**RE: Planning Justification Report Addendum – 167-171 King Street South, Waterloo
Zoning By-law Amendment (Z-25-23)
OUR FILE 15202B**

This addendum to the planning justification report is intended to address post-circulation comments from City planning staff for the continued processing of the above-noted planning application in support of a mixed-use multi-tower development on the subject lands. This addendum is supported by a comment response matrix.

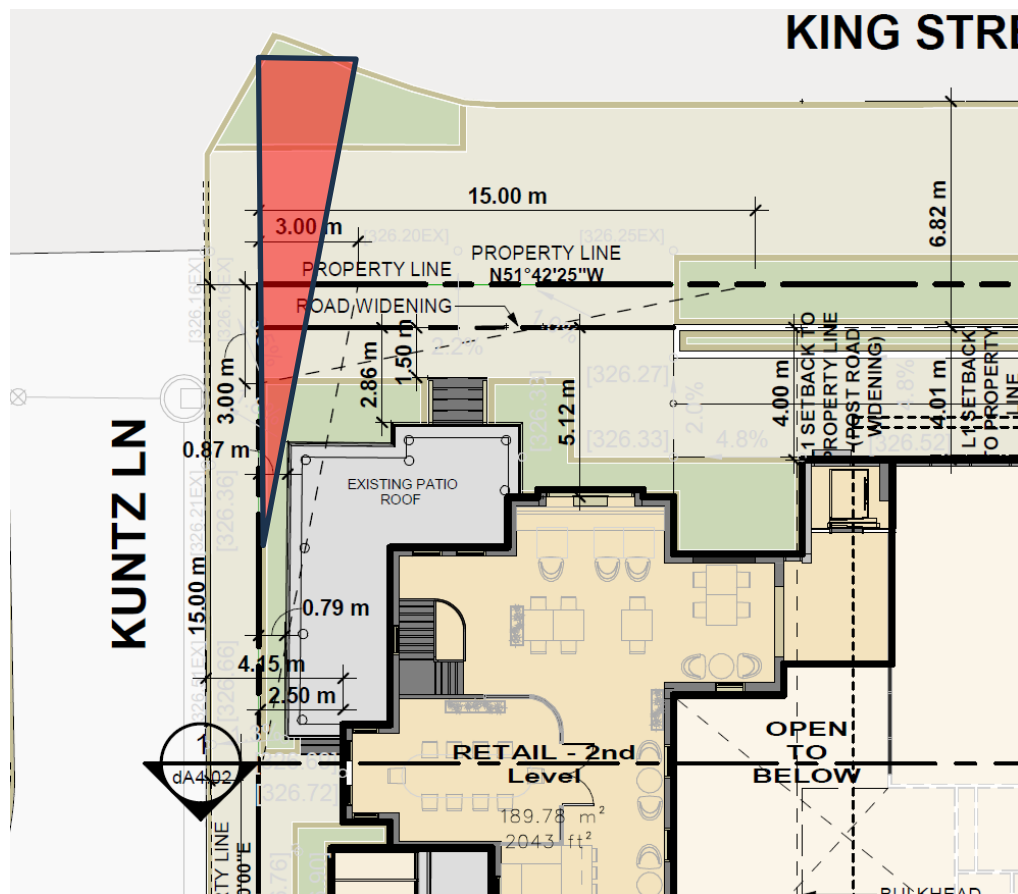
It is noted in staff's comments that in addition to the request for a reduced 1.5 metre setback from Kuntz Lane to the building podium, an additional reduced setback will be required to the relocated heritage house. We confirm that the proposed heritage building itself complies with the required 2.5 metre setback from Kuntz Lane, and rather the site-specific relief is required only to the existing and proposed covered porch addition that are attached to the heritage house.

City staff have stated that the existing covered porch is required to comply with the same 2.5 metre setback as the building, and that this setback is to be measured from the edge of the walking surface or the column. Although we cannot find this specific reference in the Zoning By-law, we confirm that the setback between the edge of the walking surface and the side lot line abutting Kuntz Lane is approximately 1.0 metre at the closest point. Accordingly, we believe that the reduced side lot line setback from both the existing covered porch and the proposed covered porch addition can be justified as these porch features are not unlike other architectural features that are permitted to project/encroach into the required yard setbacks (in accordance with the provisions of Section 3.A.5). Although covered porches themselves are not identified as an architectural feature that is permitted to project into a required yard setback, other architectural features such as balconies, architectural canopies, and cantilevered architectural elements would be permitted to encroach up to 1.5 metres into a minimum building setback and are similar to the type of encroachment requested in the revised zoning by-law amendment.

We recognize that this relief will need to be included in the site-specific provisions, and also propose that the wording be made explicit in the by-law to ensure that the proposed relief only applies to a single-storey covered porch/patio. The draft zoning amendment has been revised accordingly for the City's review and is included as an Appendix to this addendum letter.
